MAINTENANCE CERTIFICATION APPLICATION

Reference: John Francis & Daria Becker Barry
Boston Neck Road Properties
Seawall Maintenance Project
131 Boston Neck Road
Narragansett, RI 02882

I write on behalf of John Francis & Daria Becker Barry (collectively the "Applicant" or "Barry") to provide you with additional responses to the Notice of Deficient Application (2025-01-058) that is dated February 4, 2025. These responses are provided to supplement and modify the May 1, 2025 letter response along with recent feedback and submission as the Barry supplemental response to the CRMC's concerns. We are resubmitting the application with this letter. We would welcome a meeting to discuss the necessary maintenance work.

BARRY PROPERTY SEAWALL SCOUR
PROTECTION
131 BOSTON NECK RD.
NARRAGANSETT, RI

A SECTION A - PROPOSED SEAWALL PROTECTION
CB-103 SCALE: 1/2" = 1'-0"

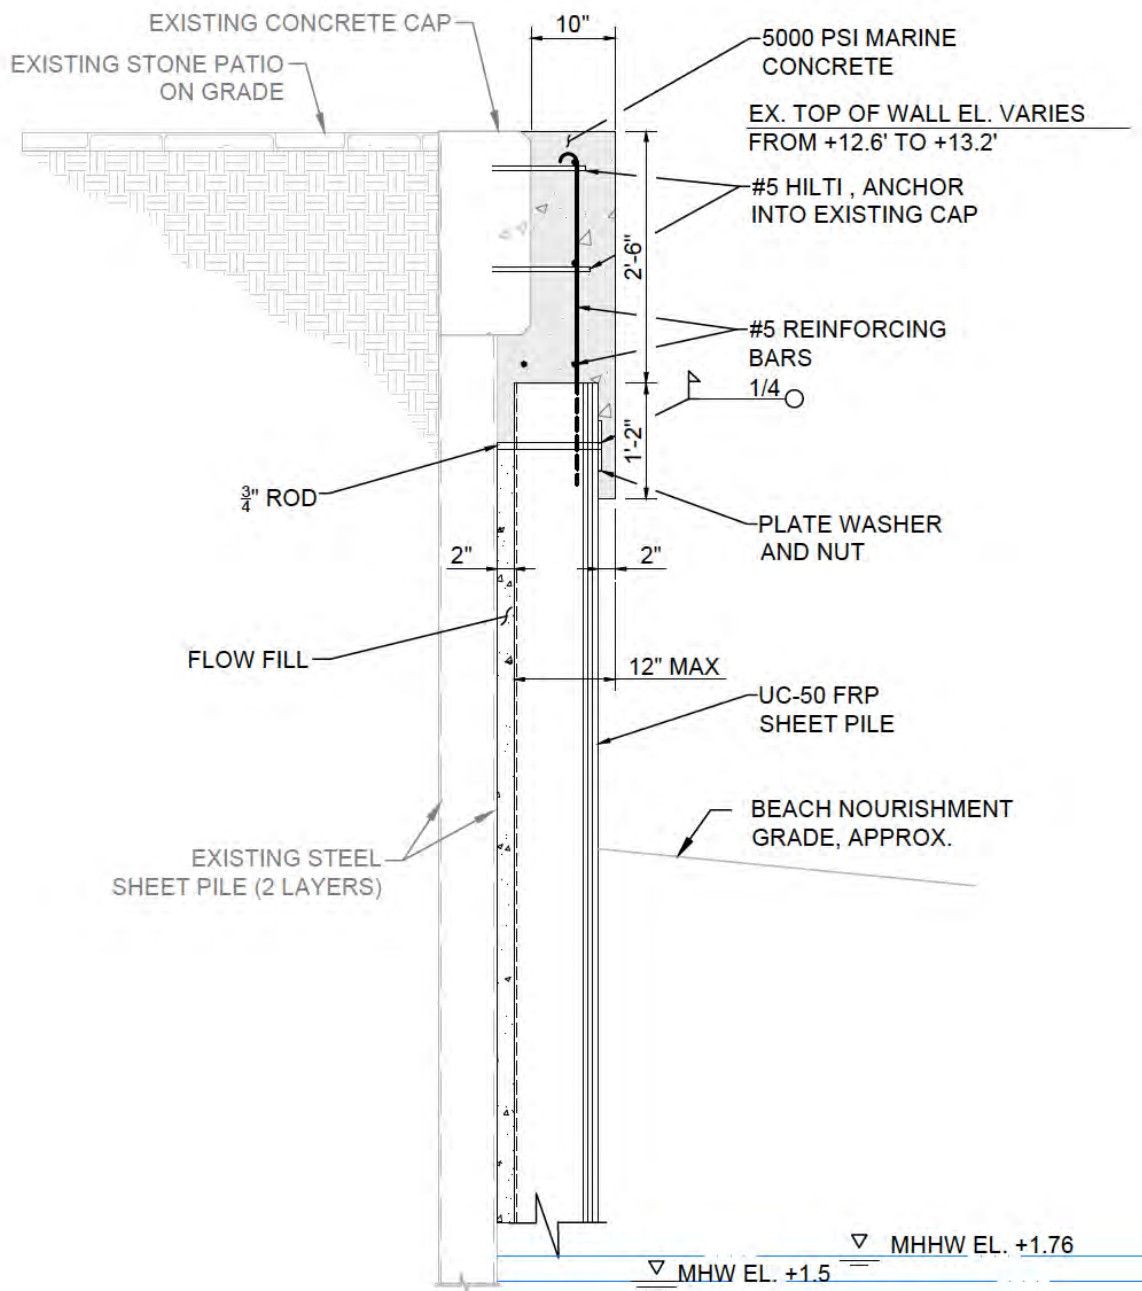
For ease of review we have included the cross sections in the narrative that clearly show the existing wall and the proposed scour protection maintenance in compliance with 1.3.1(G).6 *Maintenance and repair of shoreline protection.*

As the cross section and work description clearly demonstrate the proposed maintenance work at the 131 Boston Neck Road meets the CRMP standards for maintenance as the proposed work does not extend beyond 1 foot of the existing toe of the structure and nor does the work extend above the top of the existing wall. The work proposed is the minimum required to maintain both the functional viability and structural integrity of the wall and the upland area.
